Memo to the Planning Commission Discretionary Review

Case No.: 2017-006245DRP-03
Project Address: 50 Seward St
Permit Application: 2017.0419.4301
Zoning: RH-2 [Residential House, Two-Family]
40-X Height and Bulk District
Block/Lot: 2701/024A
Project Sponsor: Khoan Duong
John Lum Architecture
3246 17th Street
San Francisco, CA 94110
Staff Contact: David Winslow – (415) 575-9159
David.Winslow@sfgov.org
Recommendation: **Do not take DR and approve**

RECORD NO. 2017-006245DRP-03
50 Seward St.

Fig. 1. Aerial photograph of 49 Seward and 50 Seward buildings, and neighbors, with bearing determined using GPS coordinates.

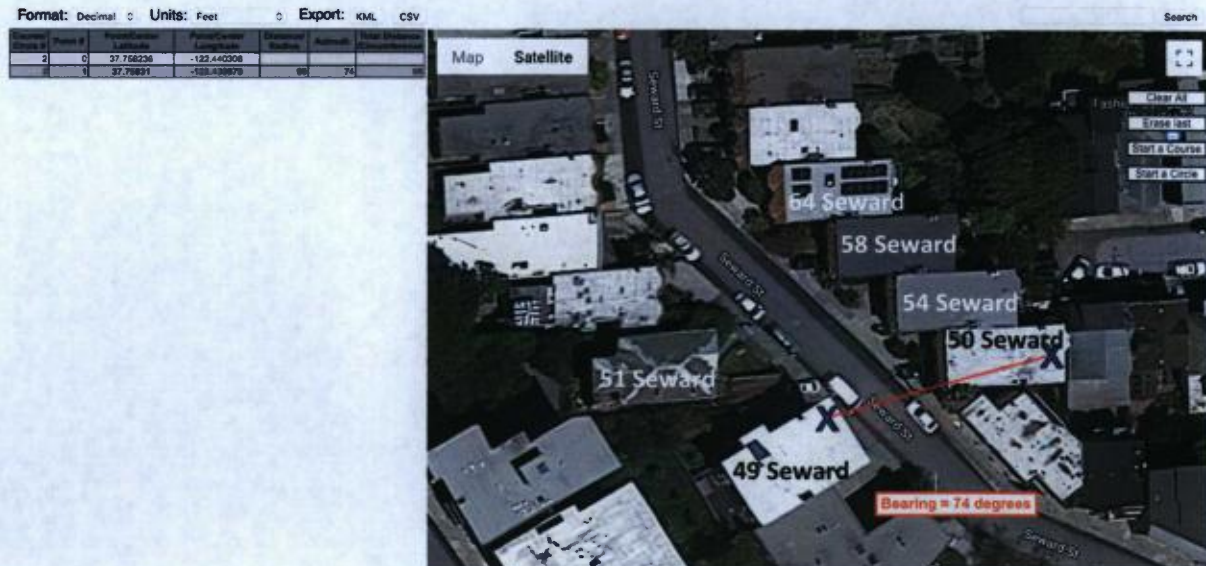
Our east-facing living room windows are the primary source of natural light into our property. Because our windows currently face unobstructed sky, we have an abundance of natural light. Please see Figure 1 which shows the compass bearing between the properties.

Fig. 2. Using the calculator available at www.sunearthtools.com, we calculated the location of the sun over our property during the summer months. The yellow line indicates the path of the sun. The yellow numbers indicate the sun's location at the specific hour of the day.

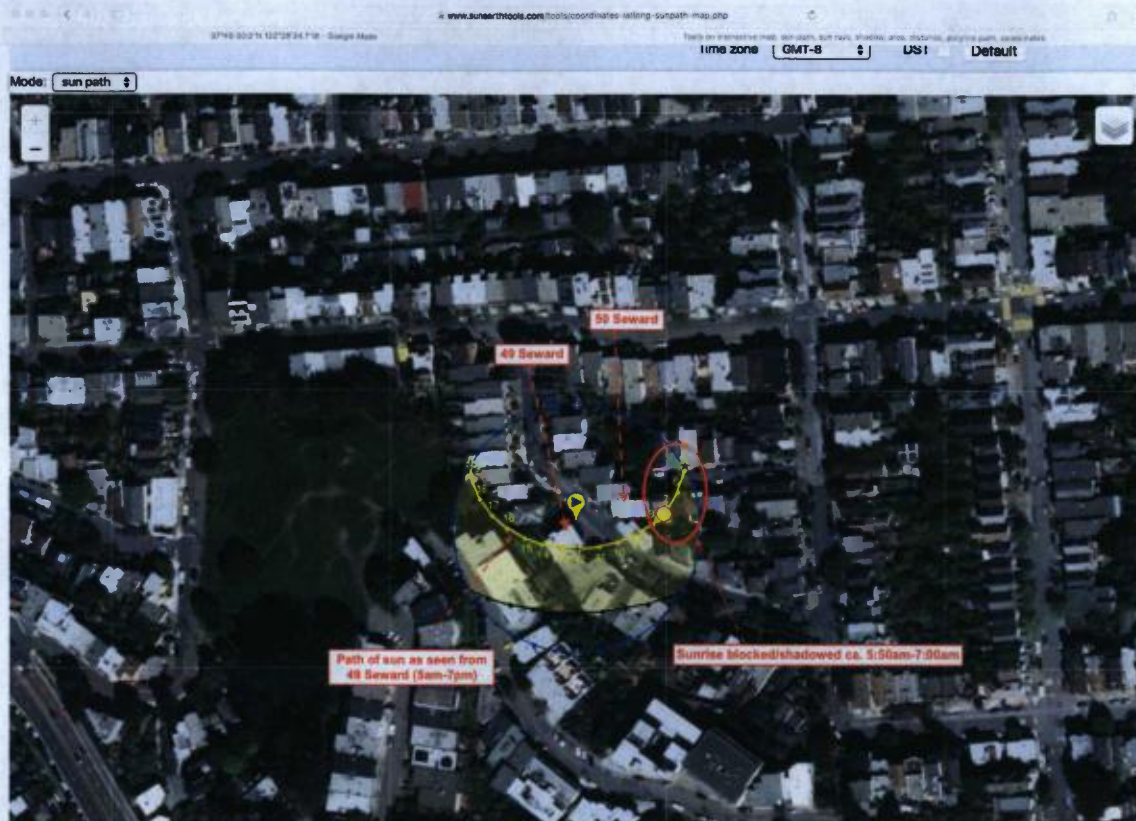
During the summer months, the proposed building at 50 Seward will directly block sunlight into our building, 49 Seward, in the early morning until approximately 7:00 am and will block light to the downhill buildings, 54, 58 and 64 Seward until approximately 11:00 am. The buildings on Carson St. will be in shadow from approximately 2:00 pm onward due to the sun's location west of 50 Seward.

Figure 2 illustrates the sun's motion with respect to our property location.

Fig. 6. Photograph of existing building at 50 Seward and its driveway, which is large enough for parking a vehicle.

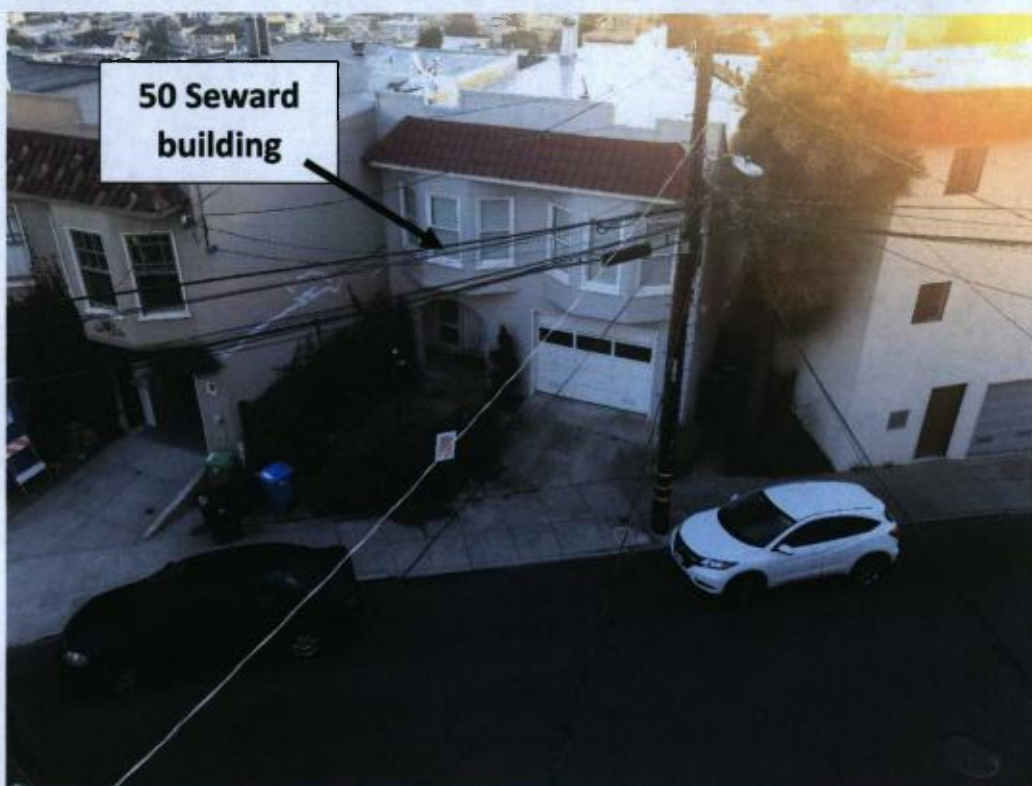
Impact 3) The design choice to remove the existing driveway (see Figure 6) in order to enable expansion of the building's footprint means that the 50 Seward owners will only be able to store one vehicle on their property. The owners of 50 Seward St. own two vehicles. After construction, their second vehicle would therefore need to be parked on the street. Since the proposed plans include the addition of a second housing unit having 2 bedrooms, it is reasonable to assume that the occupants of that second unit may also own two or more vehicles. The proposed plans would likely result in at least three more vehicles being parked on Seward St. and environs. Considering the narrowness of Seward St. (Figure 7) and the limited parking available in the neighborhood, the proposed plans will impact the neighbors' ability to park vehicles.
